# Product Change Notification

## 113288 - 00

**Change Notification #:** 113288 - 00  
**Change Title:** Intel® Server System R1304GZ4GC  
PCN113288-00, Product Design  
Update the System Rear Panel  
**Date of Publication:** October 13, 2014

Figure One

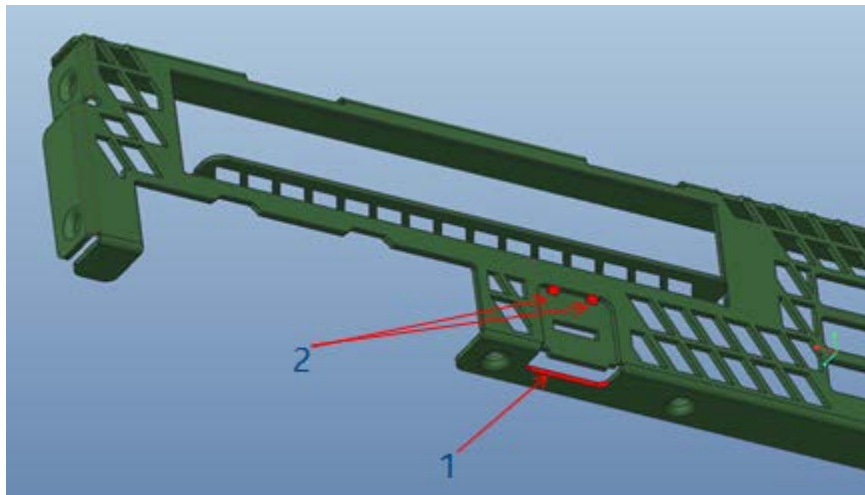
1. Add a connection at the bottom of the RMM4 (Remote Management Module 4) slot to improve structure strength. See item 1 in the Figure One.
2. Update the one big center joint to two smaller joints so that the joints will not conflict with the LAN cable connector latch. See item 2 in the Figure One.

Figure Three

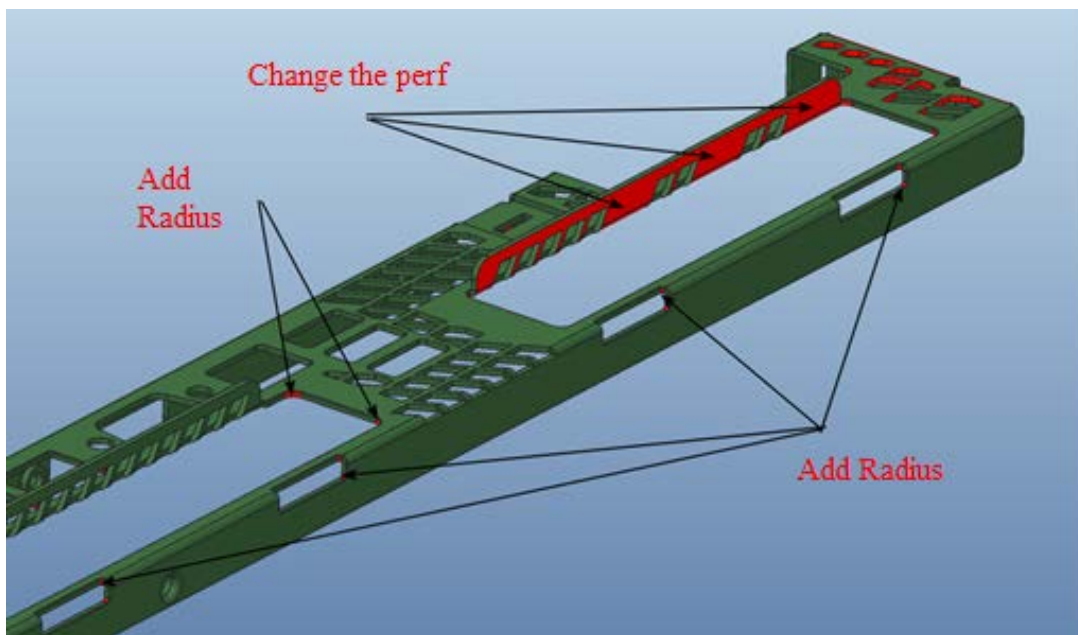
4. Update the perf and add radius to improve structure strength. See the Figure Three and Four.

Figure Five

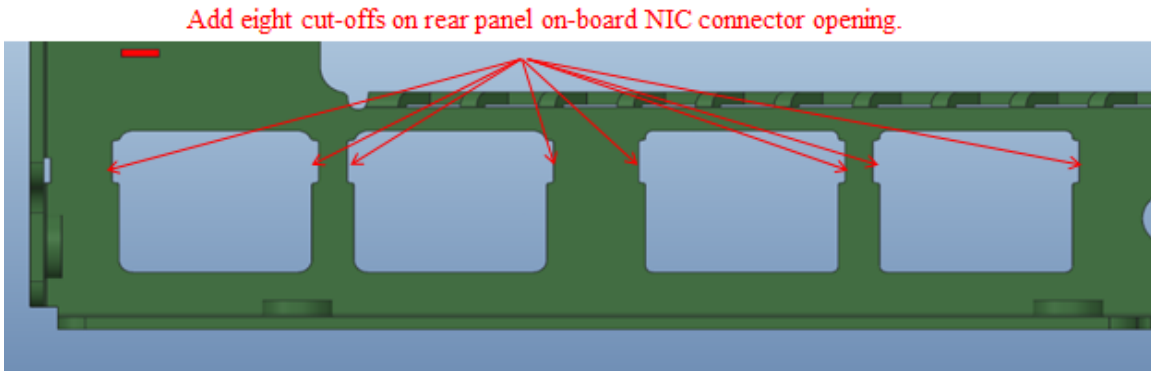
5. Add eight cut-offs around the on-board NIC (Network Interface Controller) openings to improve the LED visibility. See the Figure Five.
